AN ORDINANCE TO AMEND ARTICLE 6 (Landscaping of Parking Lots and Typical Conditions/Corner Lot Diagram)

Section 1. Be it ordained by the Board of Commissioners of the Town of Huntersville that the Zoning Ordinance is hereby amended as follows:

Typical Conditions/Corner Lot

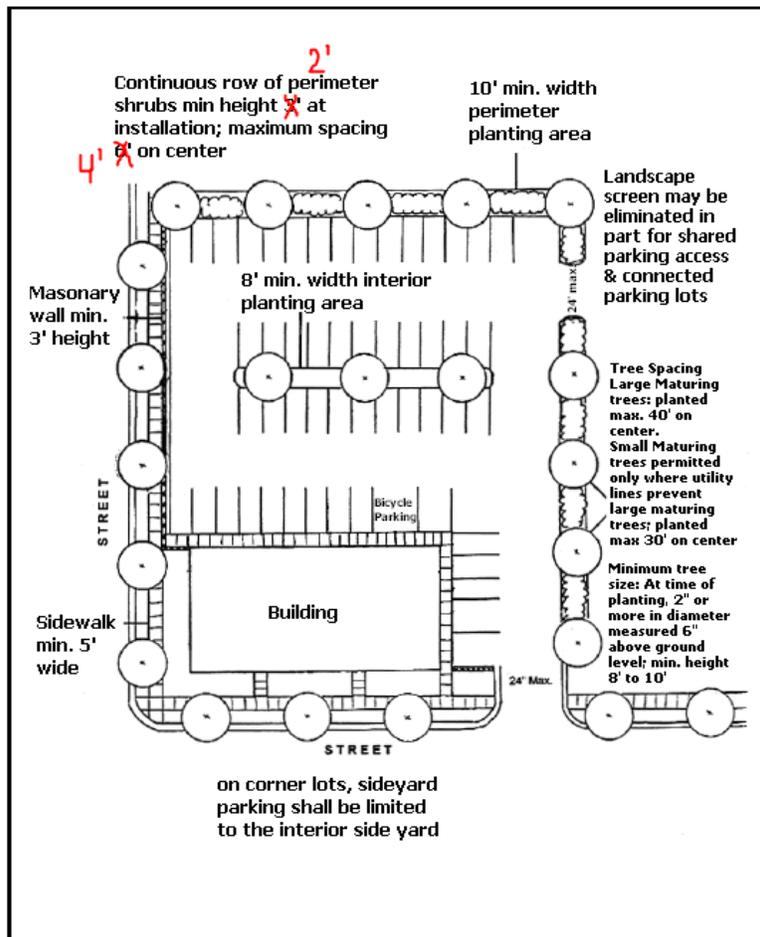
- A. Screening shall be provided by installing along the perimeter of the parking lot a continuous row of evergreen shrubs max. separation 4'-6" on center **but in no case less than what is necessary to achieve a complete visual screening depending on the variety of shrubs planted** (minimum height 2' 3" at installation, expected height at maturity at least 6' **except adjacent to street right-of-way where the expected height at maturity is at least 4'**) and/or a masonry wall 3' to 6' in height. This screen may be penetrated for access between parking lots.
